SERVICE LETTER

No. 833

Piper Aircraft Corporation

Cabin Pressurization System Rupture Disc
Elimination

COVER PLATE DETAIL (P/N 48893-02)

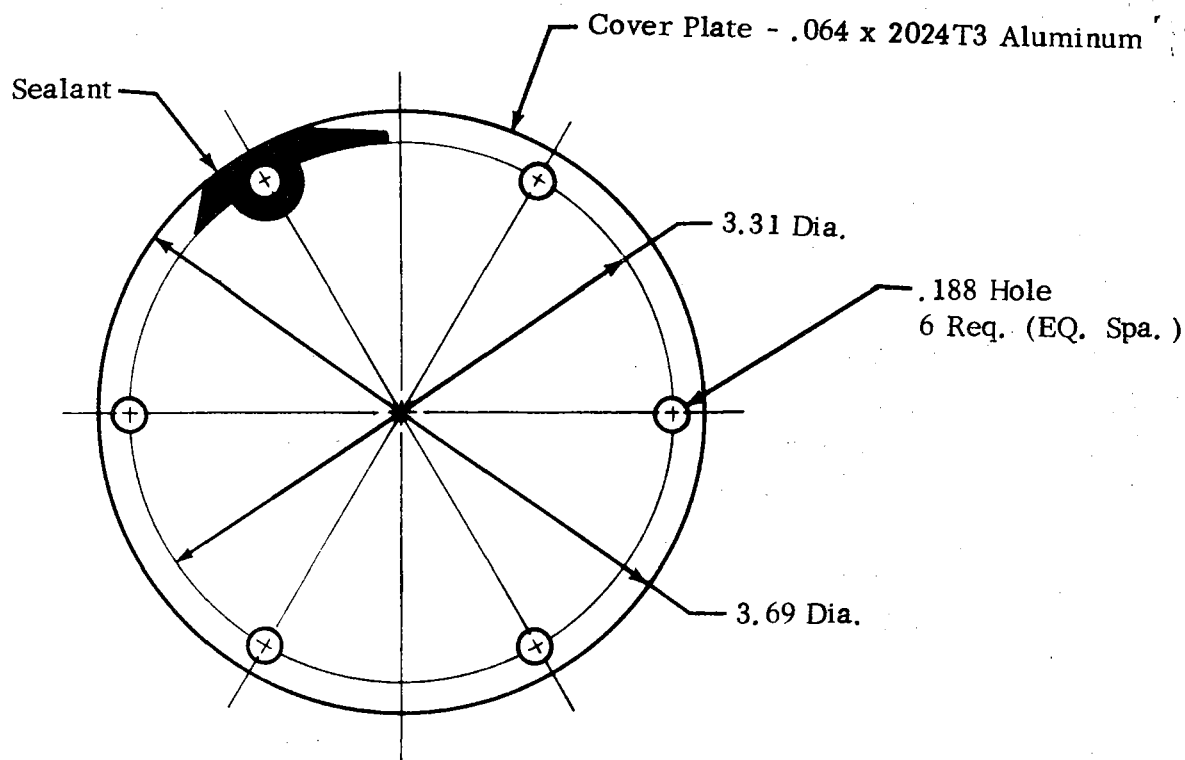
Purpose: The current cabin pressurization system on the above referenced models no longer requires the rupture disc assembly (formerly installed on rear of aft fuselage pressure bulkhead, sta. 274). Further, Rupture Disc Assembly, Piper Part Number 48683-00 is no longer supplied for field replacements through the factory Customer Service Sales Division.

This Service Release authorizes replacement of the Piper Part Number 48683-00 Rupture Disc Assembly (and related Placards, Piper Part Number 47582-00) with a cover plate that may either be fabricated locally or obtained through your Piper Field Service Facility. This product refinement announcement is intended to lower the operating cost of your Pressurized Navajo or Cheyenne cabin pressurization system by eliminating a redundant component.

1. Remove left access panel, located between sta. 274 and sta. 296, from aft fuselage.
2. Locate and remove the rupture disc assembly, installed on rear of sta. 274 pressure bulkhead, by removing the six screws and washers.

3. Remove the rupture disc placards from the forward and aft sides of the pressure bulkhead by drilling out the attachment rivets.
4. Fabricate cover plate per above detail or order plate from Piper Aircraft Corp. under part number 48893-02.

5. Clean cover plate and sta. 274 bulkhead, in the area where the rupture disc assy. and rupture disc placards were removed, with a non-corrosive solvent. Let dry.

6. Apply MIL-S-7502 Sealant (Products Research Comp. PRC-1221 or equivalent) around cover plate and around each hole, as shown on above detail, to make one continuous bead of sealant.

7. Install cover plate on sta. 274 bulkhead with the six screws and washers previously removed.
8. Apply sealant under head of MS20470AD3 rivets and install in rivet holes where placards were attached. (Note: Rivets need not be formed if sealant is allowed time to cure. Check cure time on sealant label.)
